# Groundwater Application Review Summary Form

Application # G- 18931

GW Reviewer Joe Kemper Date Review Completed: 6/13/2023

TO: Water Rights Section Date 6/13/2023  
 FROM: Groundwater Section Joe Kemper  
Reviewer's Name  
 SUBJECT: Application G- 18931 Supersedes review of 7/24/2020  
Date of Review(s)

Water-Level Trends in Nearby Wells

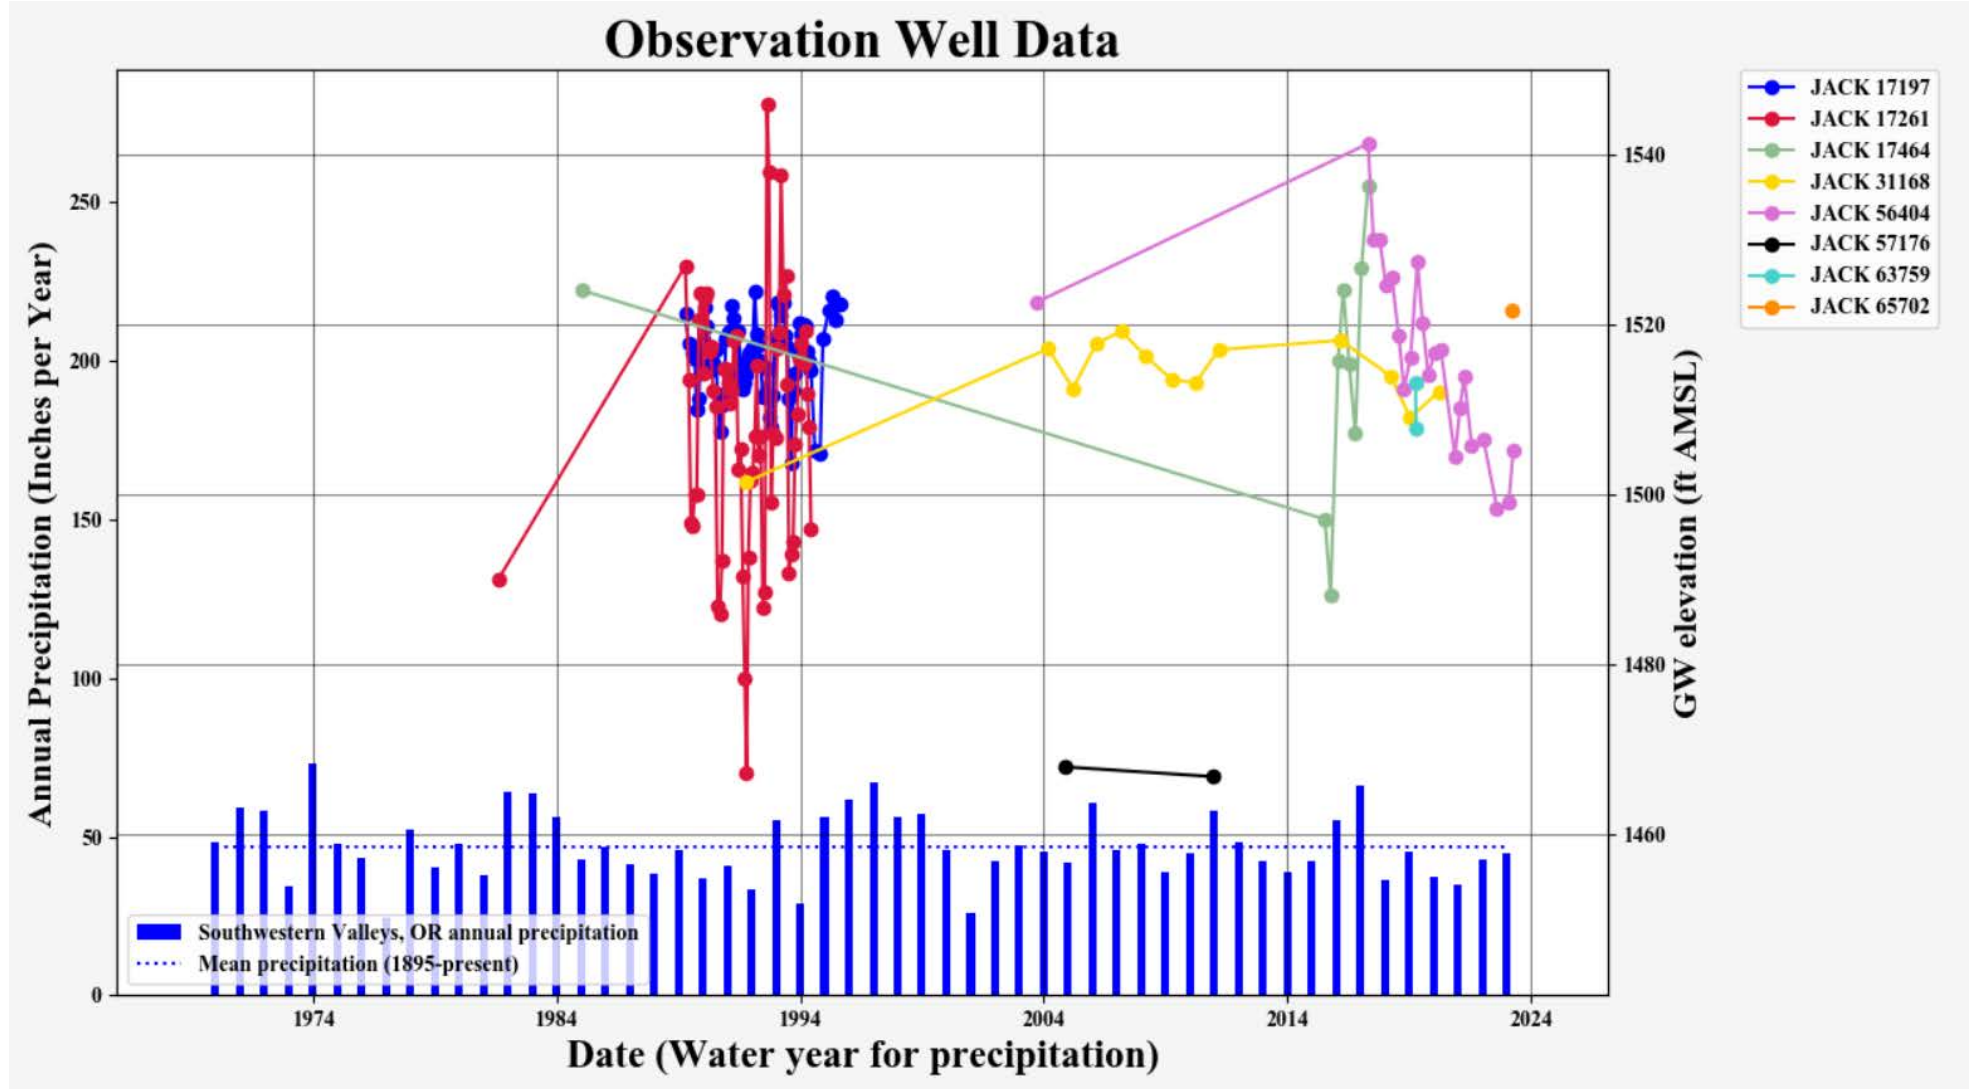
B3. **Groundwater availability remarks:** The applicant’s well accesses groundwater hosted in fractured bedrock of the Western Hayfork terrane. Bedrock at this site is overlain by ~50 feet of unconsolidated terrace sediments, which do not appear to be a source of water. Well yields in TRS 38S/3W-S27 are low (median = 10 gpm), and yields typically decrease with depths beyond 200-300 feet, both of which are typical for the fractured bedrock aquifers in the area. Water level trends in adjacent OWRD observation wells indicate that aquifer levels respond to both seasonal precipitation and year-to-year precipitation variation. Observation well JACK 56404 located within one mile of the proposed POA indicates that groundwater levels have declined approximately 35 feet from 2017 to 2023 when comparing first quarter measurements (it should be noted that 2017 was an above average precipitation year). Starting from a near average precipitation year, a decline of approximately 22 feet is observed between 2019 and 2023. Based on these data, groundwater in the vicinity of the proposed POA does not meet the definition of excessively declined or excessively declining per OAR 690-008-0001(4) and (6) and does not appear to be over appropriated. However, the magnitude of declines in the target aquifer exceed decline conditions for current groundwater rights (e.g permit G-15743) and would exceed decline conditions for this water right if issued. As a result, the proposed use is found to be not within the capacity of the resource.

**Theis (1935) Distance Drawdown Modeling Parameters and Results**

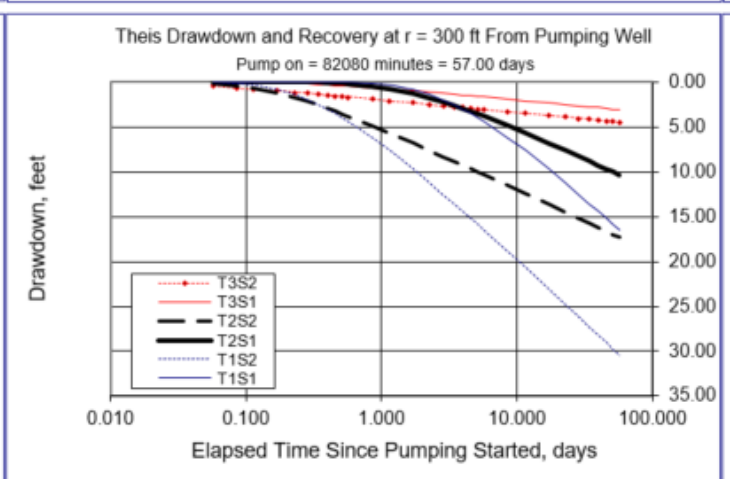
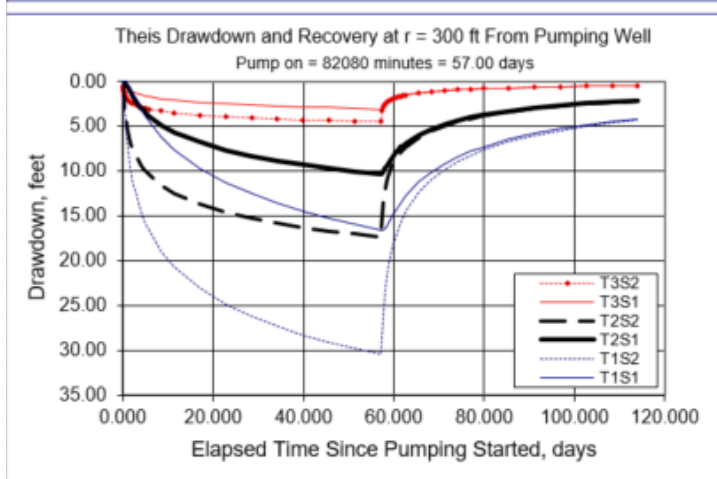
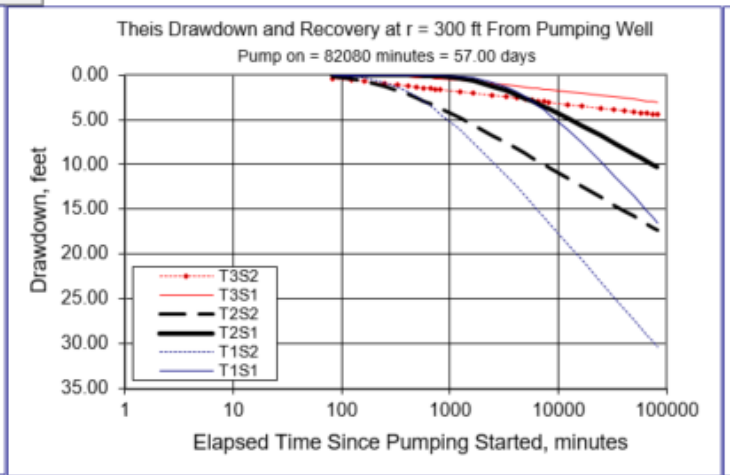
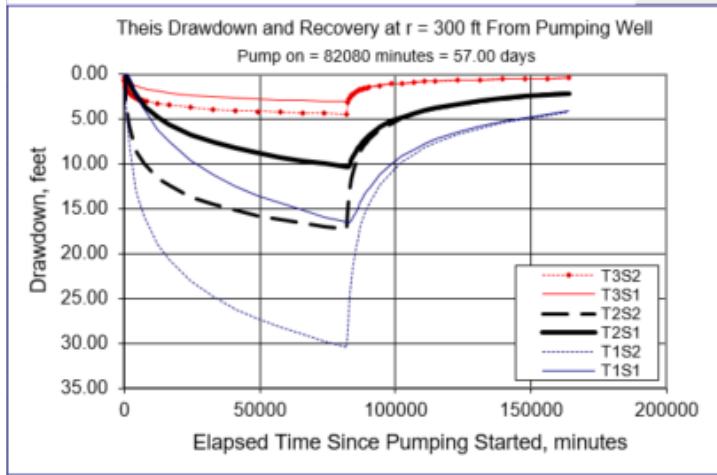
This area has relatively high groundwater development; there are ~150 well logs filed in section 27 and 11 groundwater POAs within a mile of the applicant’s well. The Theis equation (1935) is used to estimate maximum well-to-well interference from the proposed use (5 AF total at 20 gpm for 56.6 days to the nearest tax lot, ~300 feet). The resulting drawdown is expected to be less than 10-15 feet. If issued, water use, static water level, and interference conditions should be applied.
